Product Change Notification

113812 - 00

Change Notification #: 113812 - 00
Change Title: Intel® Server Chassis P4304CR2LFKN
PCN 113812-00, Product Design, Label
Update the Safety label with an EAC logo
instead of a GOST logo and Change
Capacitor and Cable on PDB
Date of Publication: April 21, 2015

Figure-1: Pre-Change

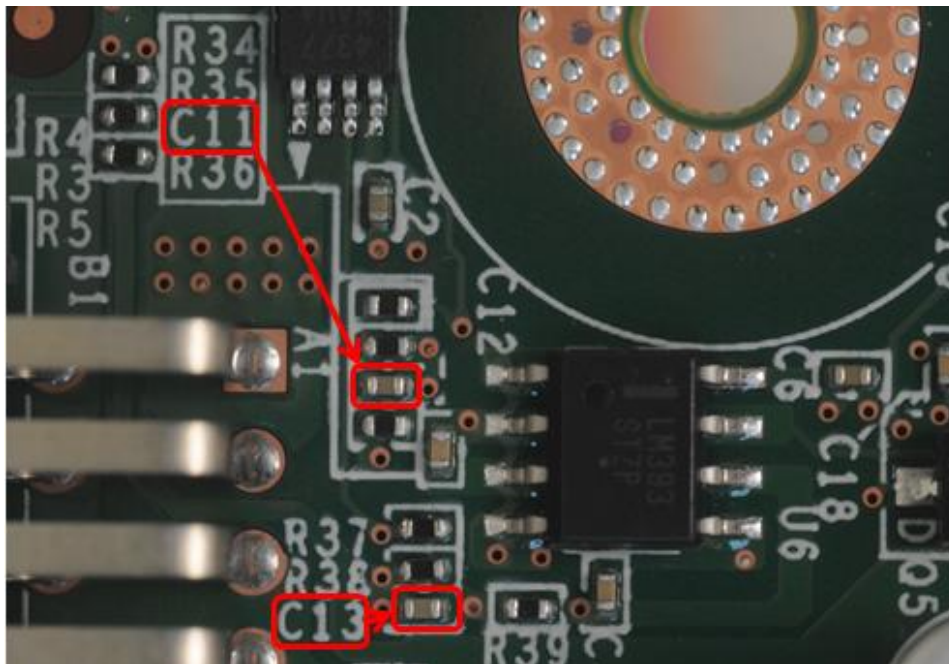
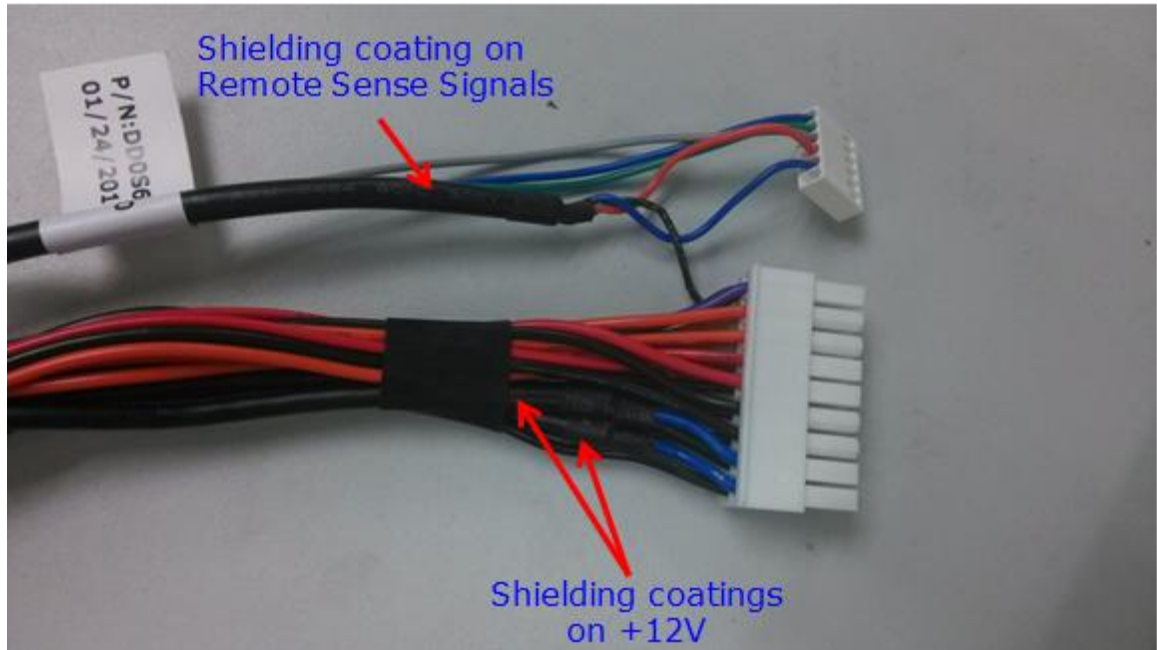
1. Update the Safety Label: Put an EAC logo instead of a GOST logo for certification update. Please see Figure-1 and Figure-2 below for details.
